ECE/TRANS/WP.29/GRE/2009/5
16 January 2009

REGULATION No. 53

Proposal for draft amendments to Regulation No. 53

Proposal for Supplement 11 to the 01 series of amendments to Regulation No. 53

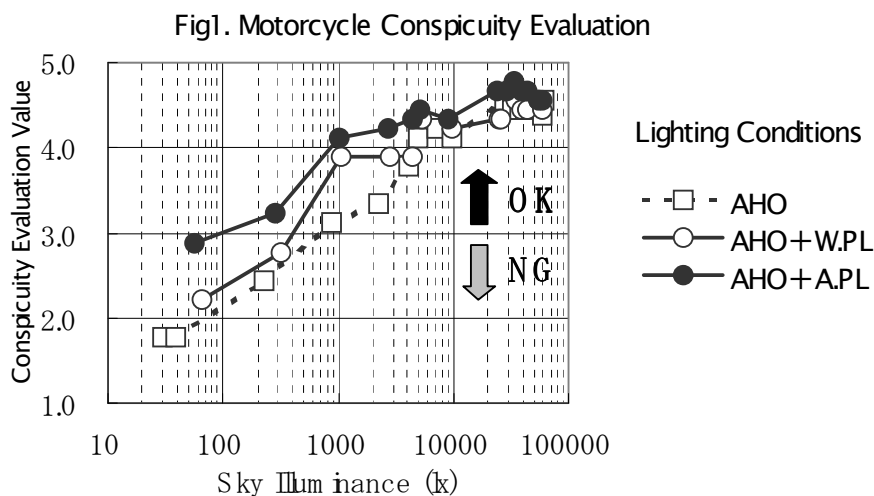
The results of the conspicuity evaluation for motorcycles followed by four-wheeled vehicles with daytime running lamps (DRL) on (Fig. 1) indicate higher motorcycle conspicuity evaluation values for the lighting condition of automatic headlamp on (AHO) with the addition of white position lamp rather than AHO only, and these values are even higher for AHO with the addition of amber position lamp. The effect of the amber position lamp on the improvement of conspicuity is especially prominent under conditions where sky luminance is low (about 5,000 lm or below) (for details, see "GRE-60-23").

Fig. 2 Motorcycle Conspicuity Evaluation

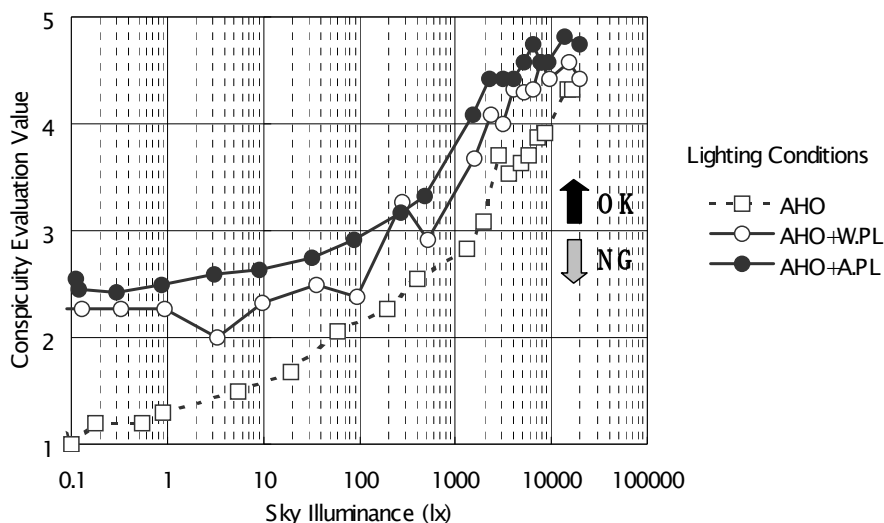
Furthermore, in the case of night driving where four-wheeled vehicles use the passing beam instead of DRL when following motorcycles, the results of the conspicuity evaluation for those motorcycles (Fig. 2) also show higher conspicuity evaluation values for the lighting condition of AHO with the addition of white position lamp than AHO only, and these values are even higher for AHO with the addition of amber position lamp (for details, see "GRE-60-24").
